## Product Change Notice (PCN)

**PCN Number:** PCN-0377235R-01

Product(s) Affected: *CPT-191985-SMT-TR*

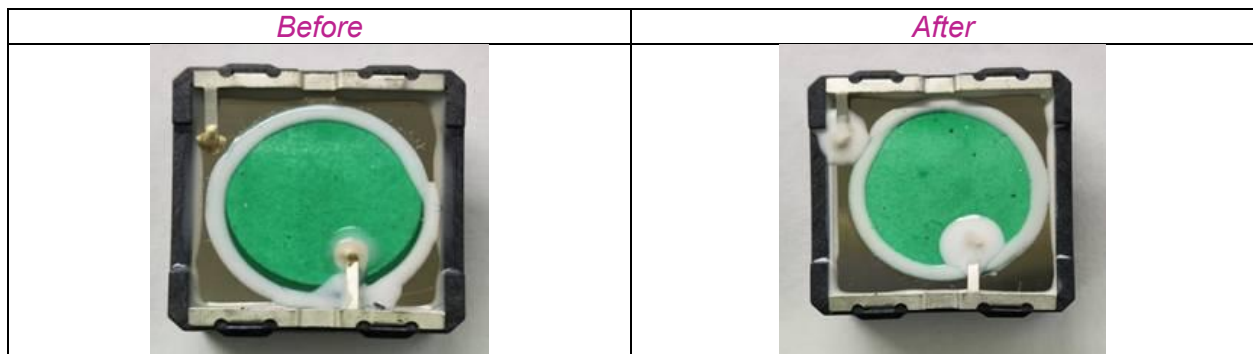
Reason(s) for Change: *Prevent oxidation in long term usage.*

Description of Change: *Increasing protective glue between the two pins and the piezo element internally.*

Additional Information: *Picture of internal change is below.*
